Technical News Bulletin

Elmira, New York, Feb. 19, 2009

Kit Significantly Improves Veritas™ iM Rotate Mechanism

Figure 1: Modifications to upper parts of the rotator

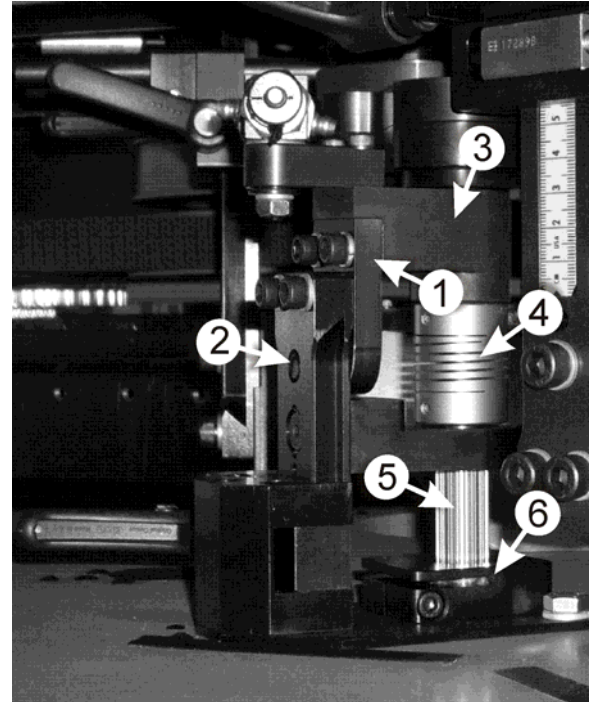
The failure of the helical beam coupling was caused by the pivot of the rotator head at a location that caused the coupling to be axially misaligned when the rotator head was adjusted to hold down the bottle during rotation. This area of the rotator mechanism was improved by modifying the design of the coupling to place the pivot axis of the rotator head at a point that changed the axial misalignment to angular misalignment (refer to Figure 1). The angular misalignment is now between 1 and 2°, which is well within the 5° rating of the coupling.

The failure of the spline shaft and bushing from abrasion was caused by fretting corrosion of the spline shaft and the spline coupling. Fretting corrosion is caused by the combination of corrosion and the abrasive effects of corrosion product debris often seen in equipment with moving or vibrating parts. On the Veritas iM rotator this failure is caused by chafing of similar materials (the spline shaft and spline bushing) while sliding or vibrating under load. Two steps were taken to prevent and eliminate the failure of these parts.

1. A dry film lubricant is applied to the spline bushing.
2. The side load and vibration of the spline shaft was decreased by moving the spline bushing to the bottom of the shaft. An additional benefit was better alignment and support of the spline shaft.

1. New pivot plate
2. Pivot pin
3. Modified rotator body
4. Helical coupling
5. Spline shaft
6. Spline disk shield and disk shield housing

Figure 2: Modifications to lower part of rotator

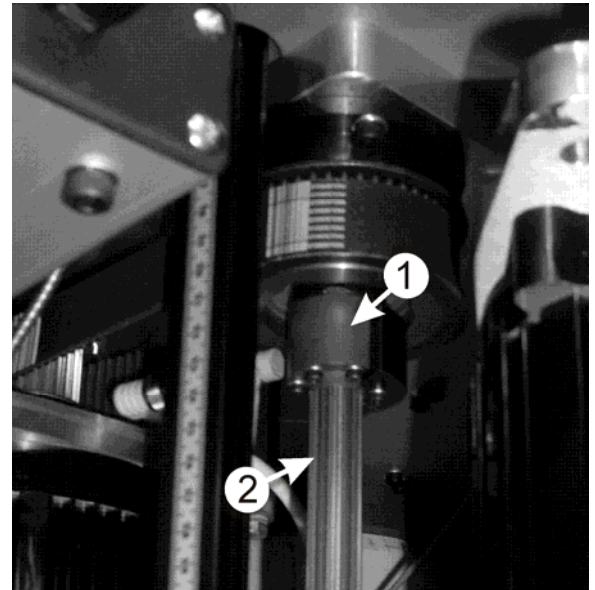
Failures of the rotate head were caused by the spline shaft hitting the inside of the rotate head drive shaft when the rotator was turning. By relocating the spline bushing to the bottom of the spline shaft, spline shaft interference was eliminated (refer to Figure 2). This also decreases the maximum possible misalignment of the rotate head and spline shaft to ranges that are well within the tolerances for these parts. In addition to relocating the spline bushing, a Nylatron® disk shield has been added to a new housing located above the top plate to reduce the amount of debris that can enter the bushing.

1. Spline bushing relocated to bottom portion of the spline shaft
2. Spline shaft
